AMPEX TAPE RECORDERS  
SERVICE BULLETIN NO. 1B, MODEL 300

SERVICE BULLETIN #4  
MODEL 300

REPLACEMENT INSTRUCTIONS FOR REPLACING CYCLOHM DRIVE MOTOR  
WITH BODINE DRIVE MOTOR, SERIAL NOS. 113 TO 500

SERVICE BULLETIN #4A

1. Brake bands.

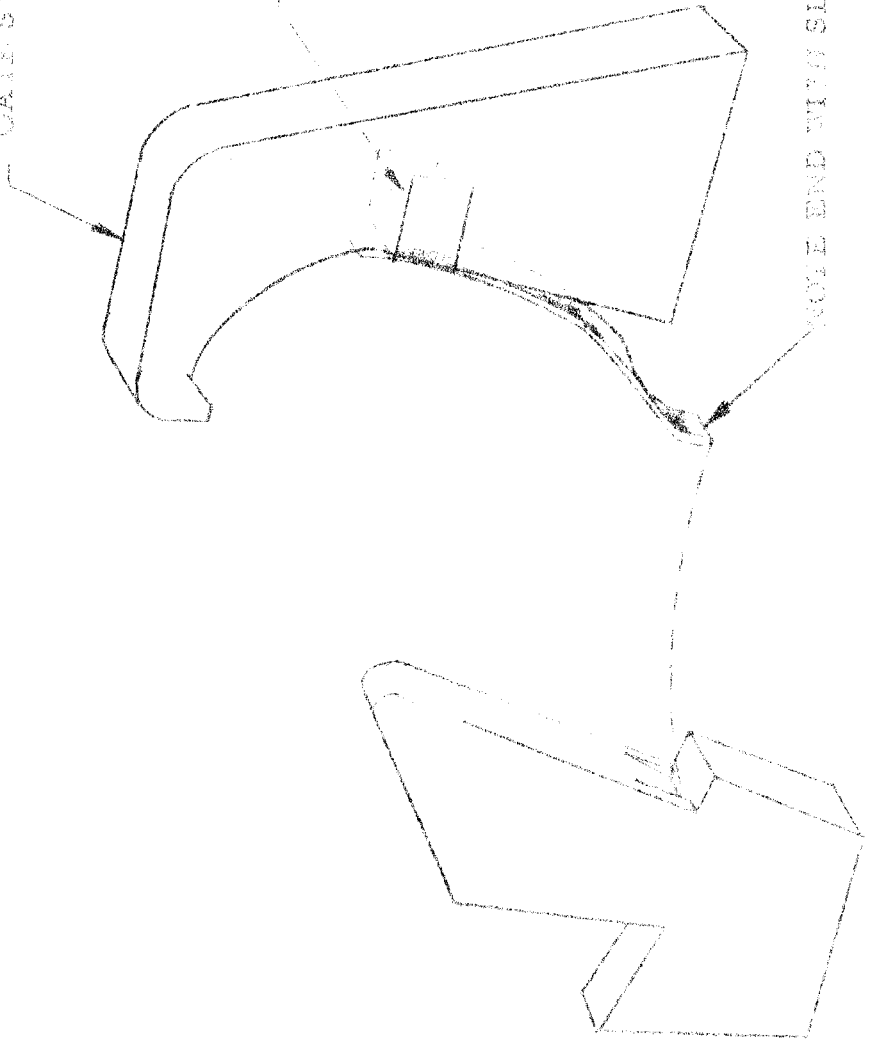
There have been several instances in which the brake bands have broken on machines that are in use. Investigation of the broken bands has revealed that the fracture has always occurred in the same place.

The brake bands have therefore been redesigned to relieve all possible strains at the point which the breakage has occurred. Two reinforcing leaves have been added to relieve the strain. The link, A-330, has been reversed. This causes band to rest more firmly against the housing and thereby prevents any tendency for the brake to drag. Adjustment of proper brakeband length is made at the point where the band is attached to the A-330 link. It will be noted that the band is slotted for this purpose. The band should be positioned so that when the solenoid is operated, the band is expanded firmly and uniformly against the inner wall of the housing, completely free of the brake drum. However, care must be taken so that the projecting portion of the band near the A-330 link bows only slightly. Excessive bending of the band at this point may be the cause of future failure, or in the case of A.C. solenoids, the cause of excessive audible noise.

After installation, the brake bands must be "run in" before brake settings will be stable. This is done by putting the machine in Rewind or fast Forward, as the case may be, and disconnecting the brake solenoid. Allow the motor to run at full speed for 10 minutes with the brakes on.

After allowing sufficient time for the brakes to return to room temperature, adjust the brakes to provide a tension of 14 oz. on the standard NAB reel hub, when pulled in the direction in which the tape unwinds.

INSTALLATION OF GATE SPRINGS

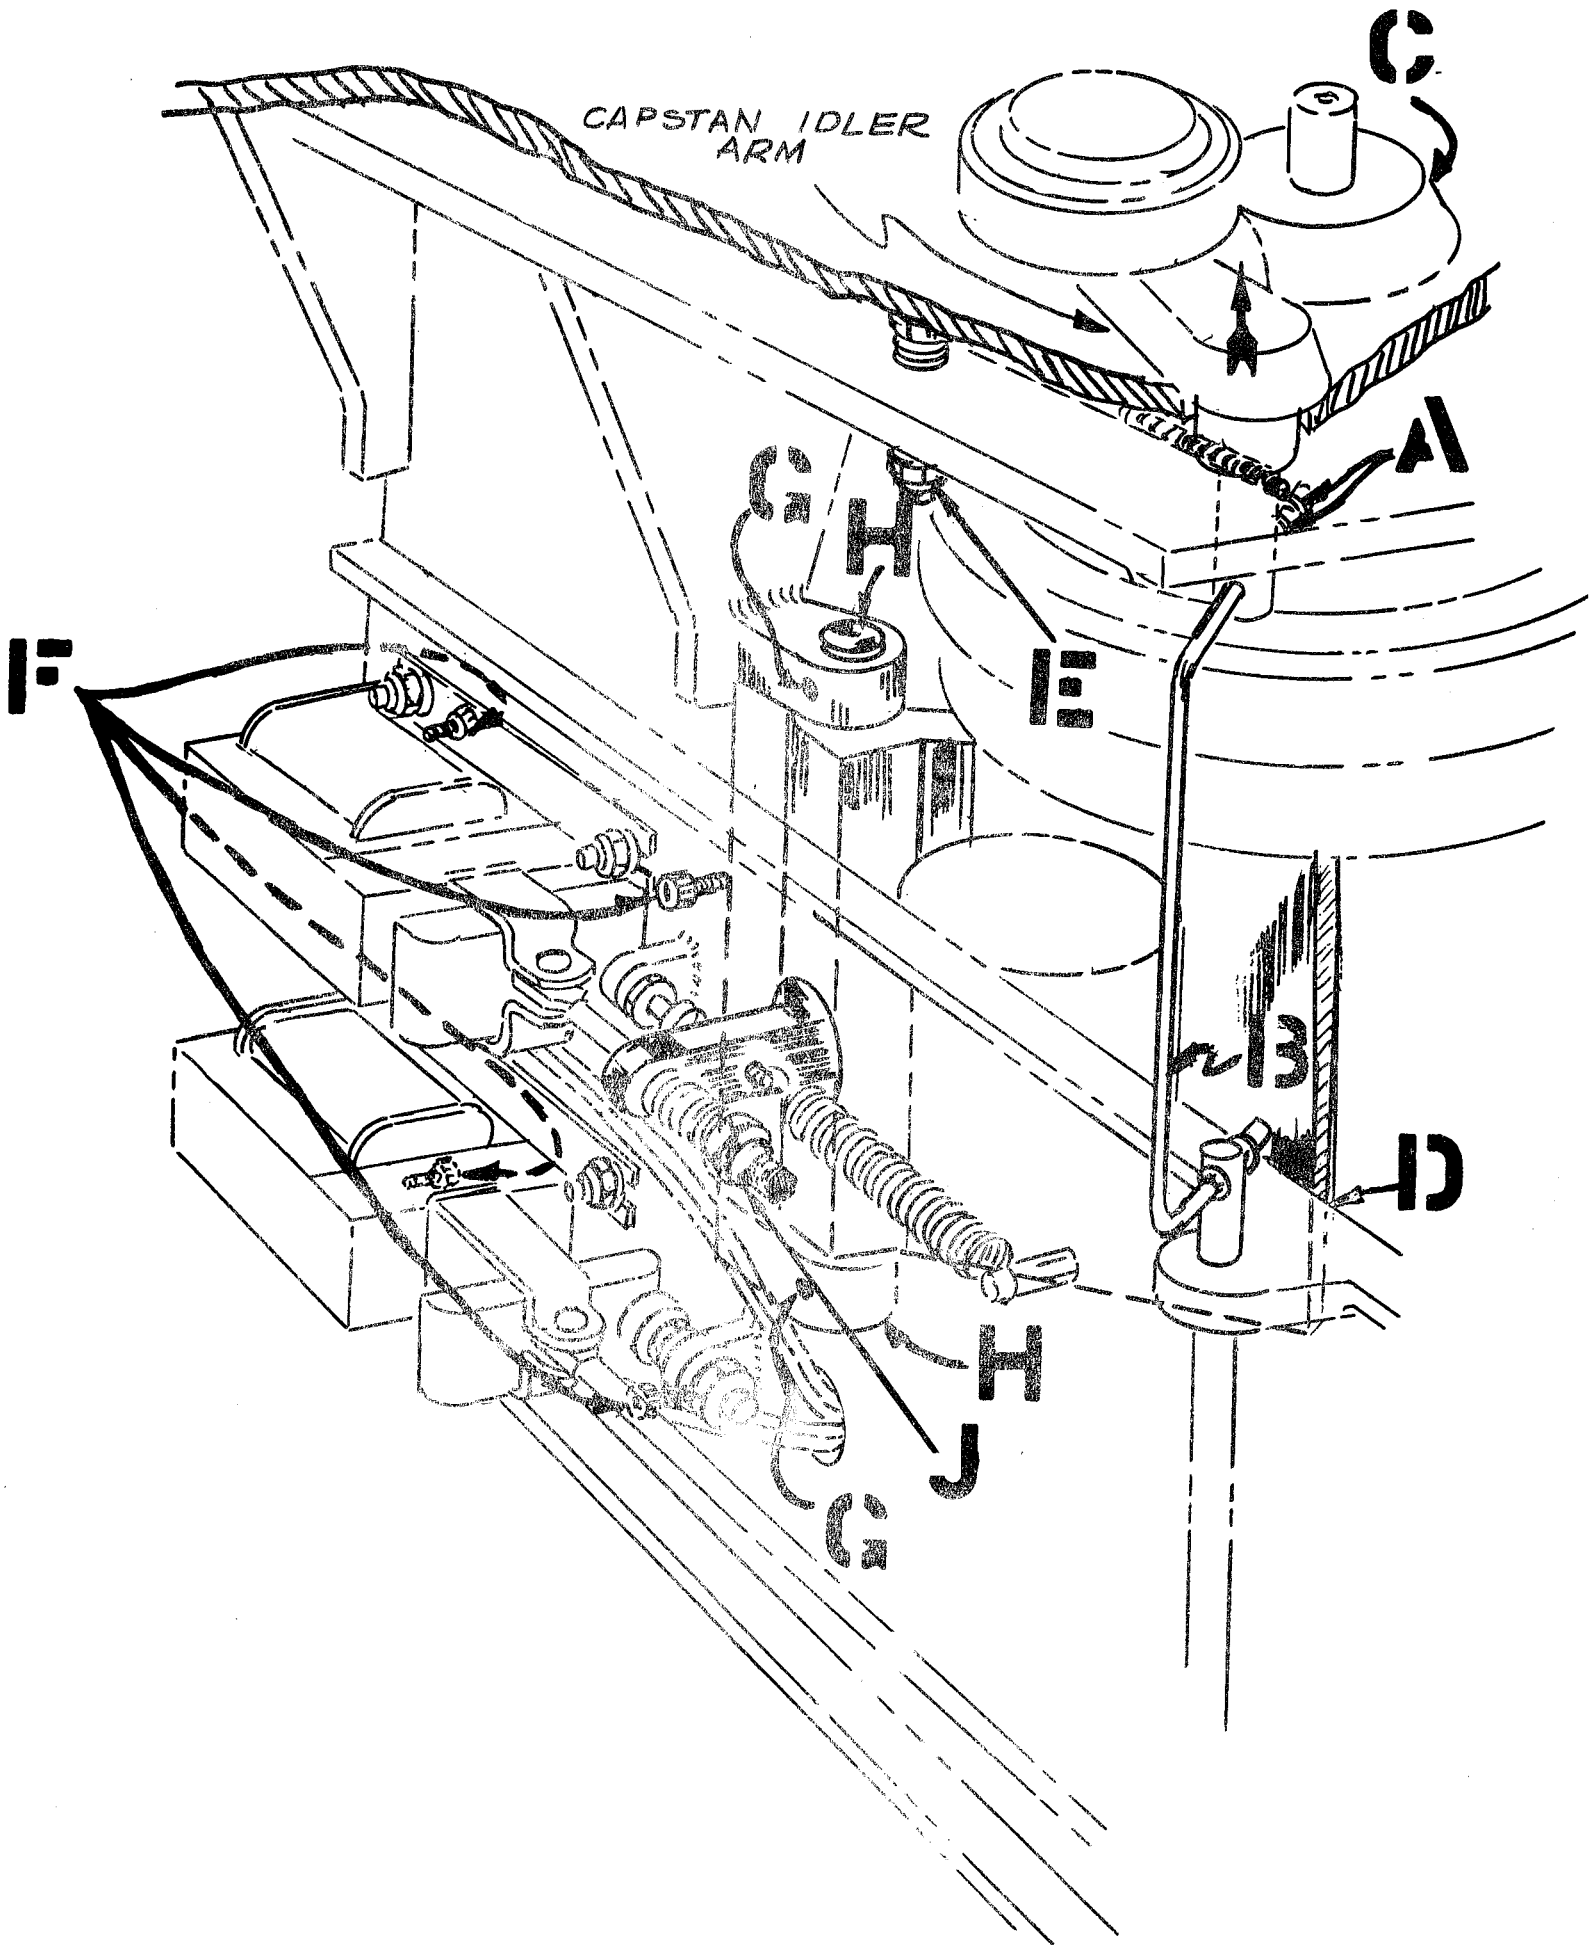
WHILE HOLDING GATE OPEN, PLACE GATE STOP POST IN POSITION AS INDICATED BY DOTTED LINE.  
LET GATE SLOWLY CLOSE. INSERT ALLEN SCREWS & TIGHTEN. REMOVE MASKING TAPE.

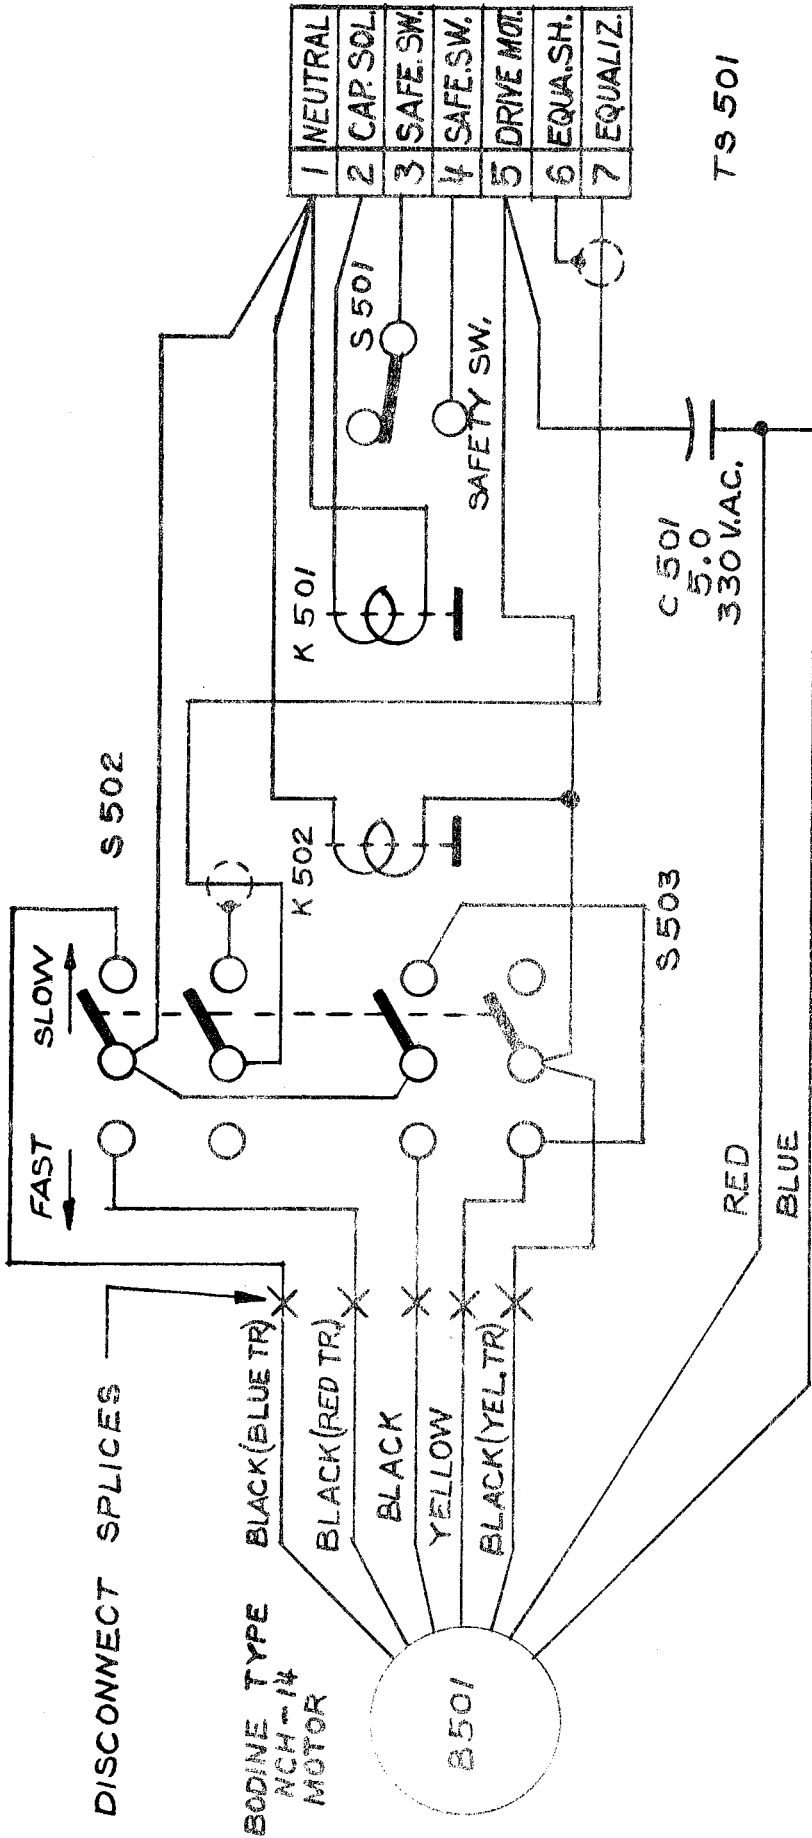
The Bodine Drive Motor which has been developed for the Model 300 runs at double the speed of the Cyclohm Drive Motor used on machines of Serial #113 to 500, and consequently uses a pulley of half the diameter. To install the Bodine Drive Motor therefore requires that a new hinge bracket be installed which will support the new motor in the proper position to engage the capstan flywheel. Also, since the windings on the Bodine Motor are different than on the Cyclohm Motor, it must be connected in a different manner.

1. Remove retaining rings "A" on Capstan Idler link "B".
2. Remove Capstan Idler link "B".
3. Remove Capstan Idler arm from Top-Plate.
4. Remove Capstan cap by loosening set screw "C".

5. Disconnect wiring harness from Drive Assembly terminal strip "D".
6. Remove Drive Assembly from machine by removing 4 elastic stop nuts "E" (only one shown).

7. Remove 4 screws "F" and drop solenoid mounting plate. Note that two screws are on the solenoid side and the remainder on the opposite side of the plate.

8. Carefully remove drive lok pins "G". Be careful not to damage ears of casting.
9. Remove two bracket hinge pins "H".
10. Remove bearings from old brackets and install in new bracket. CAUTION: In removing bearings be careful not to injure bearing dust shield. Injury to this shield could lead to freezing of the bearing.

11. Install new bracket and motor by reversing foregoing procedure.
12. Re-assemble remainder of Drive Assembly and re-install on Top-Plate.
13. Adjust solenoid adjusting nut "J" for proper speed. Since there is sometimes more than one point at which the proper speed is obtained, for stable operation, be sure nut is tightened to the point where further tightening reduces the Capstan speed.

14. Check motor return stop bumper. A 1/16" clearance between motor pulley and capstan fly-wheel is required when motor is at rest. Add or remove washers beneath bumper to attain required clearance.

FIG. 7

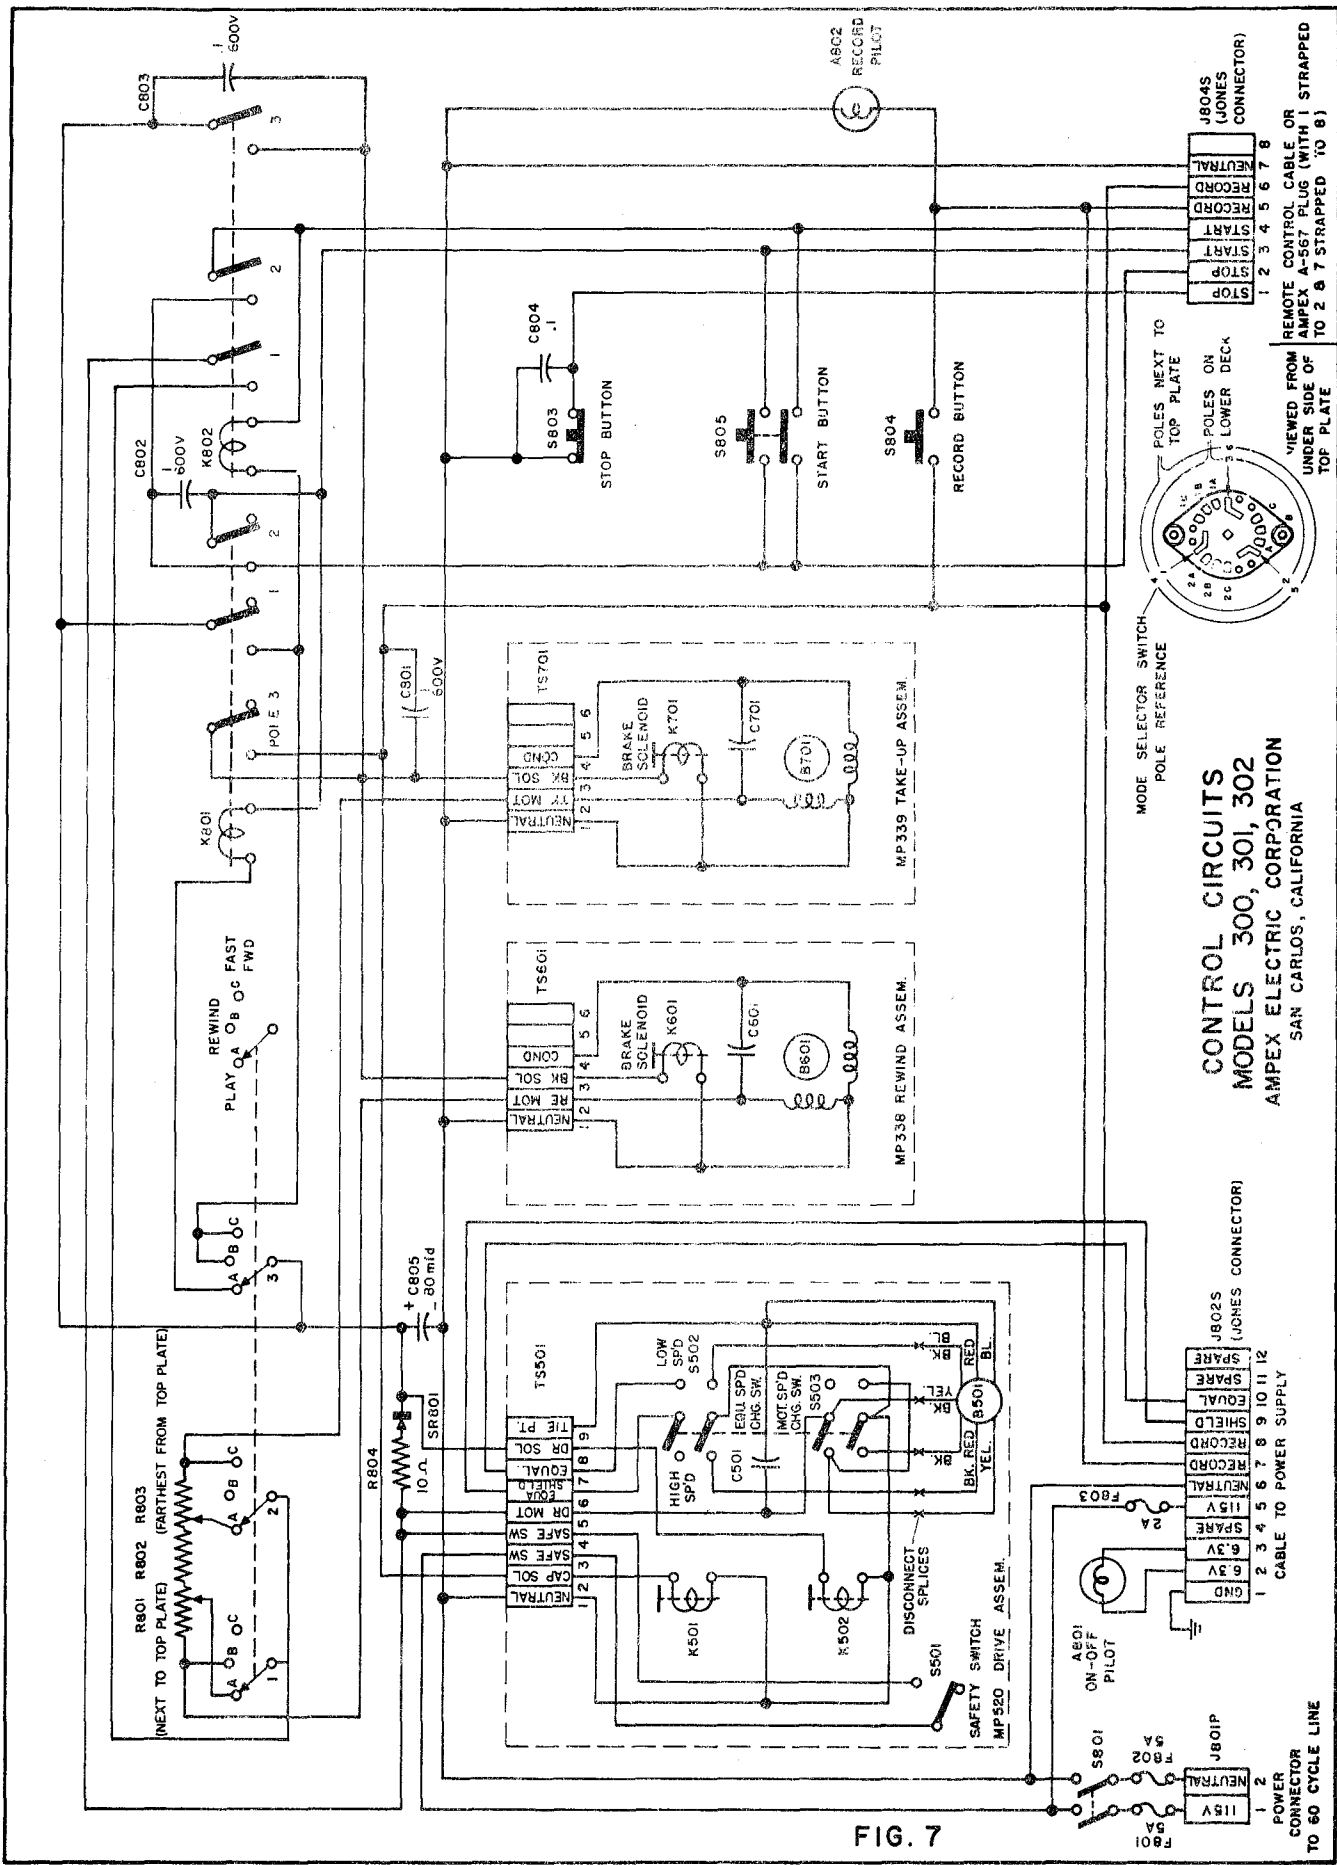
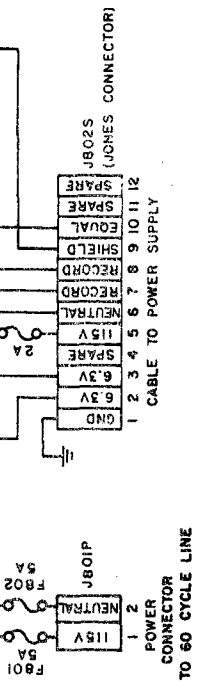
Replacement of the Cyclohm or Electric Indicator Motors in machines, Serial Nos. 501 to 699, is easily accomplished. It is only necessary to remove the old motor and the hinge bracket on which it is mounted and replace with the new parts. Removal is accomplished by disconnecting motor leads from terminal block, removing stop nut and spring connecting the solenoid to the hinge bracket, and removing the bracket and motor by unscrewing the old bracket from its hinge springs. The new parts will exactly replace the old. In Model 301 and 302 machines, the capstan assembly must also be replaced as a different size drive pulley is used with the Bodine Motor. The Bodine Motor (B-501 in the figure) should be connected in accordance with the accompanying diagram which is a replacement of Figure 7 in the Instruction Manual.
